A428 Black Cat to Caxton Gibbet Scheme

Wyboston and Barford Road Roundabouts Mitigation Note

Prepared by: Cambridgeshire County Council

Date: 8 February 2022

Additional Junctions models requested by CCC

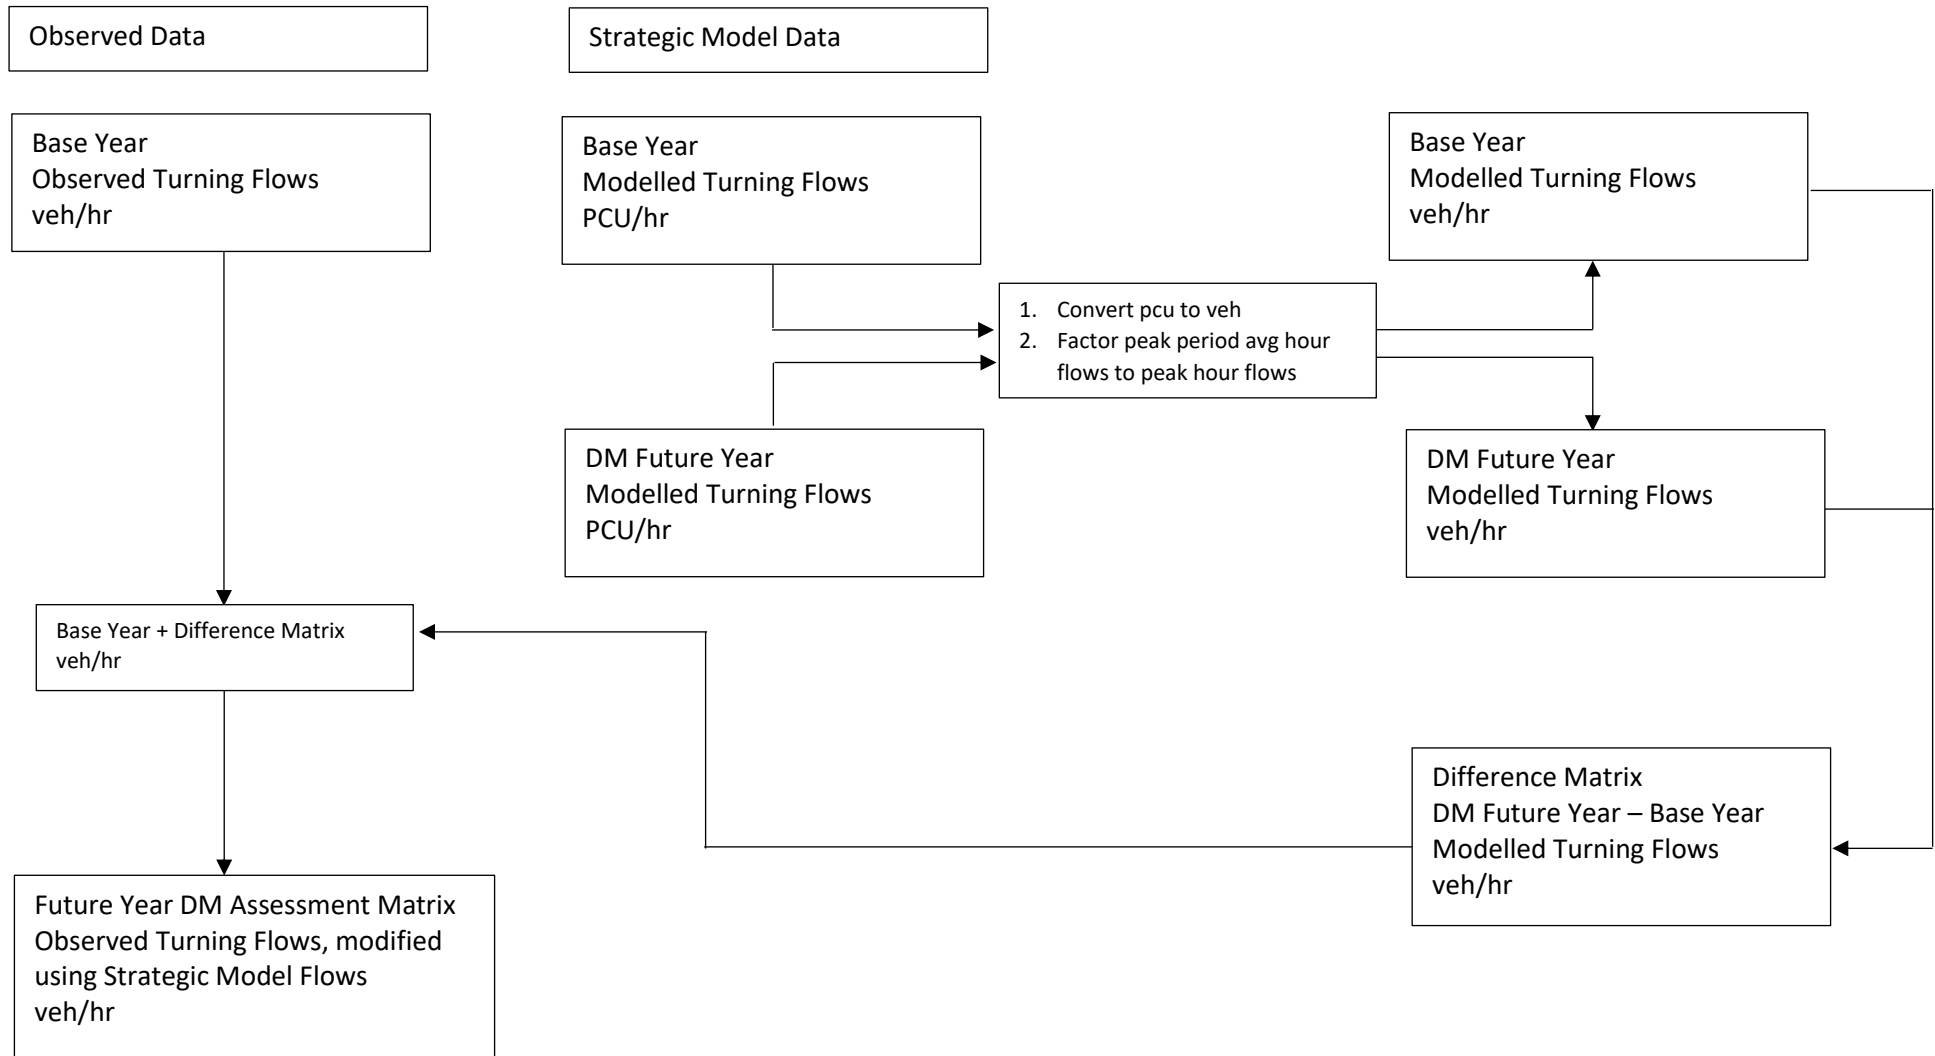
CCC note they have asked NH to assess additional junctions on Great North Road and Cambridge Road in St Neots as the strategic modelling undertaken by NH indicates that both these roads see a significant increase in traffic as a direct result of the scheme. CCC need to be confident that the adjacent junctions on these roads can accommodate the suggested increase in trips (circa 200 PCU/hour in the AM and PM Peak periods). These junctions are listed in Appendix C and their assessments should be carried out using Option 1 above.
